Title	D_SUB	
Size A3	Document Number <Doc>	Rev <RevCode>
Date: Saturday, July 05, 2003	Sheet 1 of 6

DESIGN	CHECK	APPROVAL	Model
			Title: MCU
			Document Number / Rev 1
WooYoung Telecom Co., Ltd.			Sheet 3 of 6

DESIGN	CHECK	APPROVAL	Model H750D
			Title AUDIO
			Document Number / Rev 1
WooYoung Telecom Co., Ltd.			Sheet 6 of 6

Title	DVI	
Size A3	Document Number <Doc>	Rev <RevCode>
Date: Saturday, July 05, 2003	Sheet 2 of 6

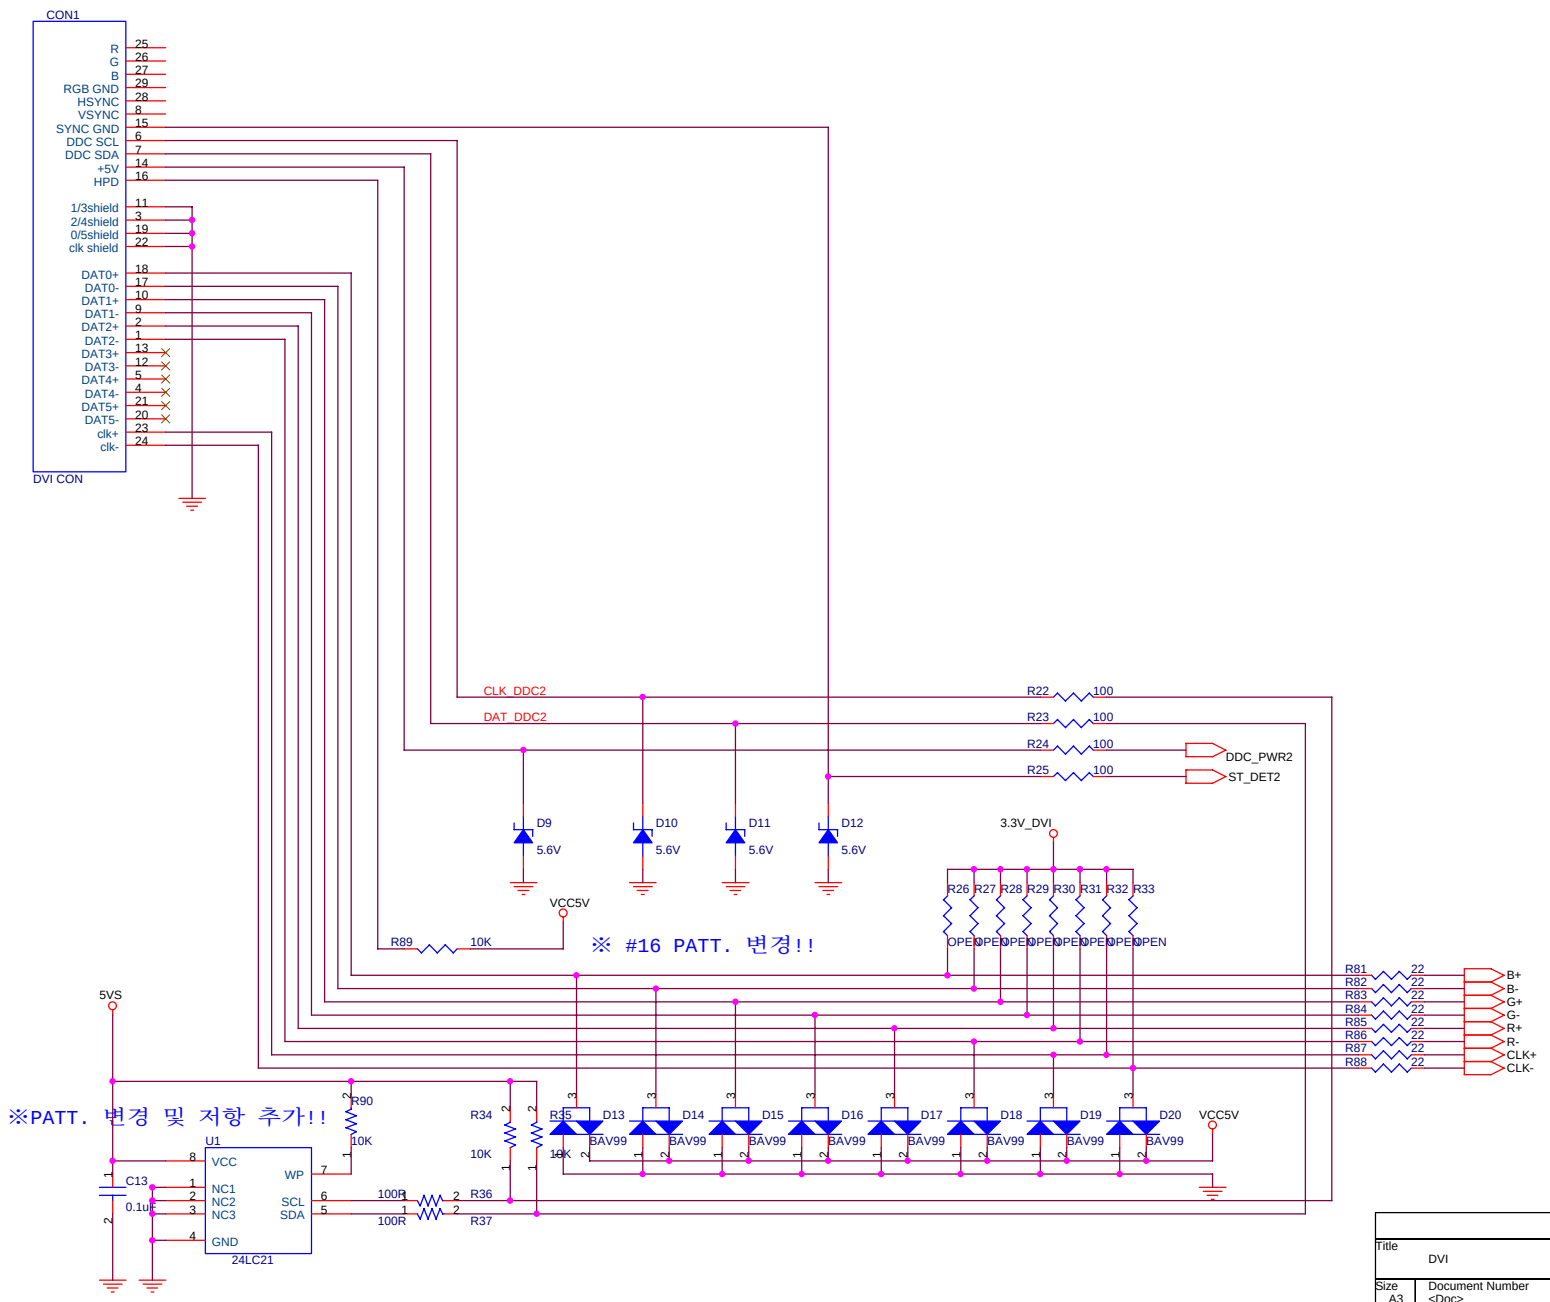
1. ST_DET2의 DVI PIN 변경

1. 24LC21의 VCLK 수정

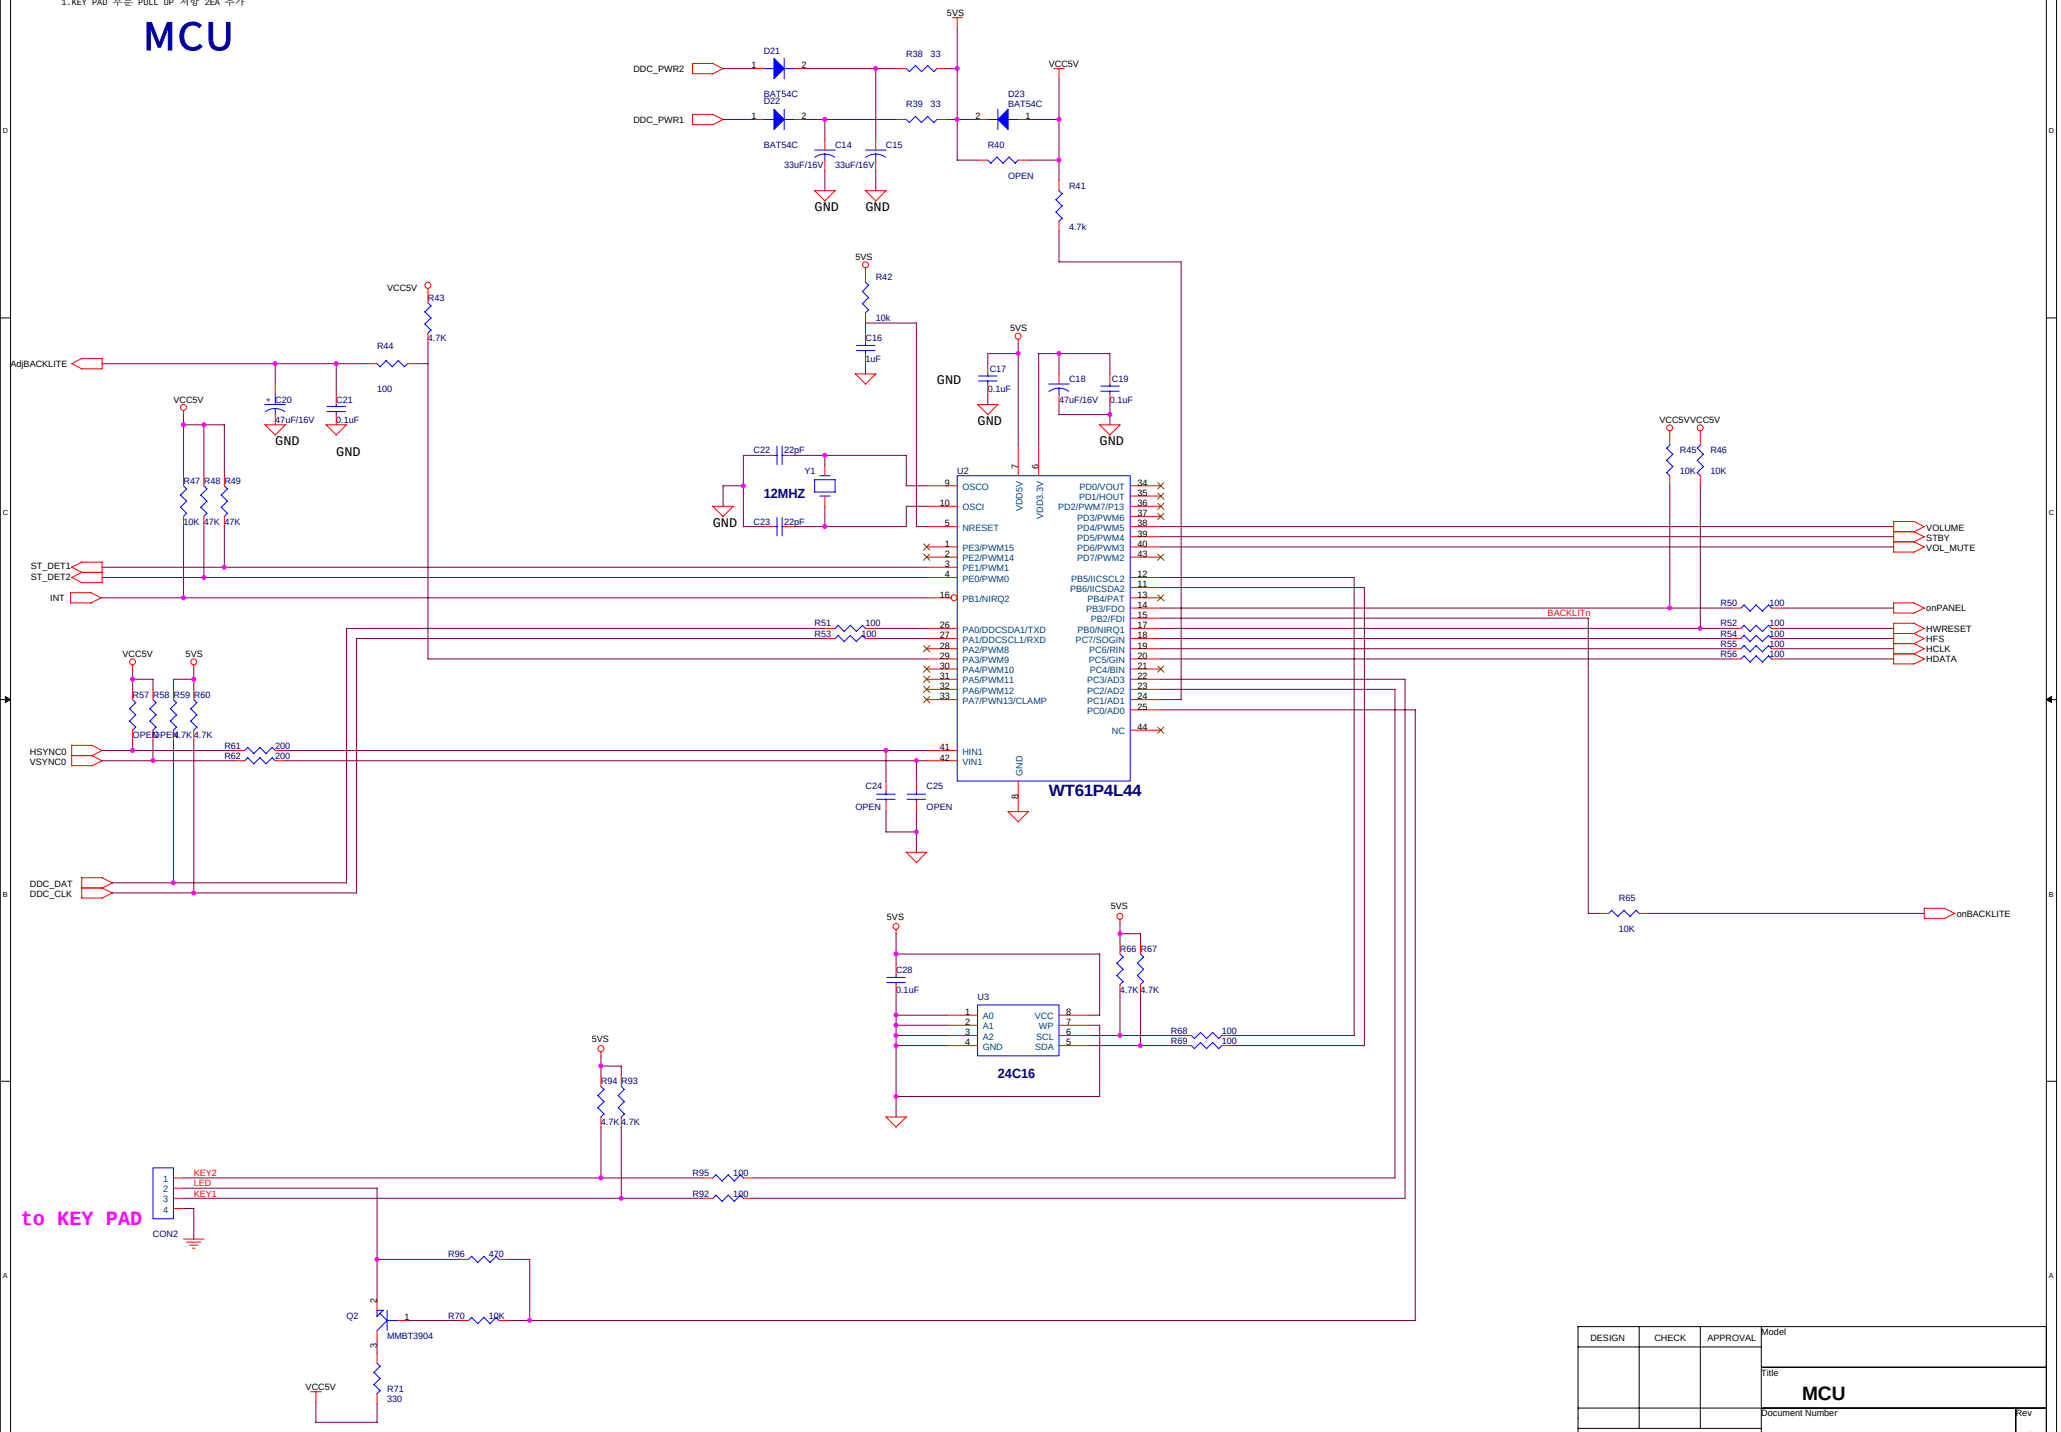
1. R43위치 이동!!

1.KEY PAD 부분 PULL UP 저항 2EA 추가
